DEVELOPMENT REVIEW COMMITTEE (DRC) COMMENT REPORT

PROJECT NAME: Publix Supermarket

CASE NUMBER: PLN-SITE-19110004

REQUEST: Site Plan Level IV Review: Rezoning from Residential Multifamily High Rise/High Density (RMH-60) to Community Business (CB) with .52 Acres of Commercial Flex Allocation and Conditional Use for 28,795 Square-Foot Supermarket

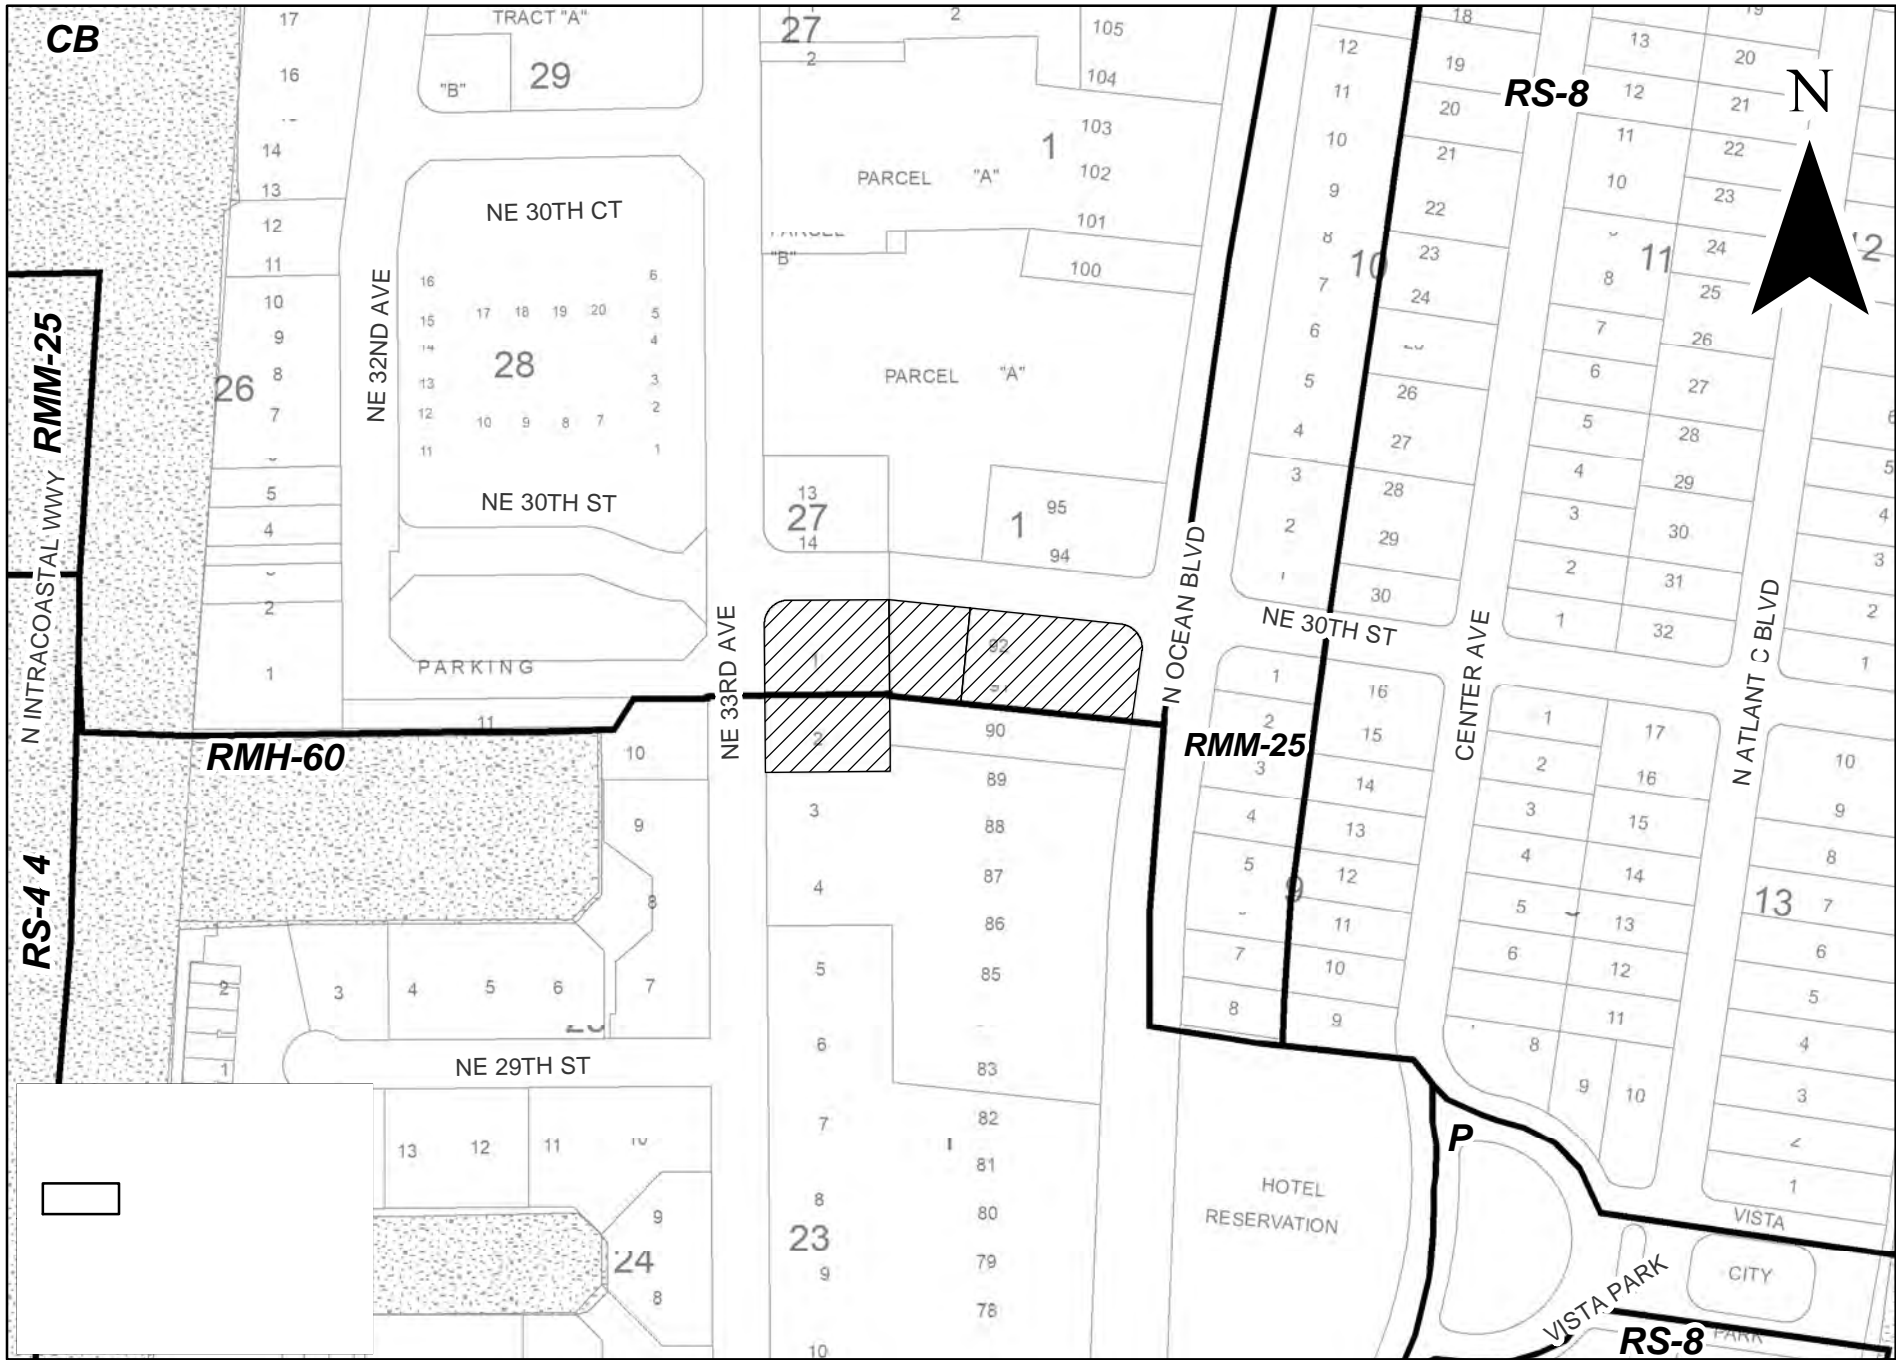
9. As proposed, the building footprint occupies the majority of the site leaving minimal space for adjustments, pedestrian respites, and wider sidewalks. The building design should be reevaluated to: (1) include a stronger building presence at the corner of Ocean Boulevard and NE 30th Street, an enhanced storefront experience fronting Ocean Boulevard and where possible along NE 30th Street, use of high quality building materials facing the public realm, and all the parking located above the building. Staff has provided more specific information in Comment #10 and #11 below. In addition, the following images are being provided as examples.
